PARTS & SERVICE NEWS

REF NO.	AT96176A
DATE	Apr. 25, 2004

SUBJECT: REPAIR OF AIR COMPRESSOR INLET VALVE (Engine S6D140)

PURPOSE: To introduce repair procedures for the inlet valve of the air compressor

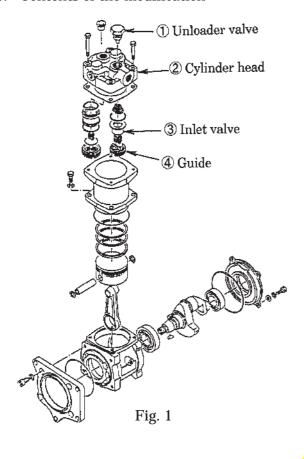
The material and the sheet thickness of the inlet valve ③ according to Fig. 1 have been improved to enhance the durability.

• Material : $15N2C \implies SUS420J2 + Mo$.

• Sheet thickness: 1.2mm \Rightarrow 1.5m

- (1) Disconnect the water and air pipes from the air compressor.
- (2) Replace the head assembly (DK487018-5222) of the air compressor with the improved part.

Meanwhile, when the unloader valve ① according to Fig. 1 is found normal, replace the sub-assembly (DK487018-5321) of the head only.

Tightening torque for the head bolt: $49.0 \pm 5.0 \text{Nm}$ (5.0 ± 0.5kgm)

(Note) Although replacement of the inlet valve ③ and the guide ④ will do the repair, since the guide can only be removed using a special jig, replace the whole head assembly instead.
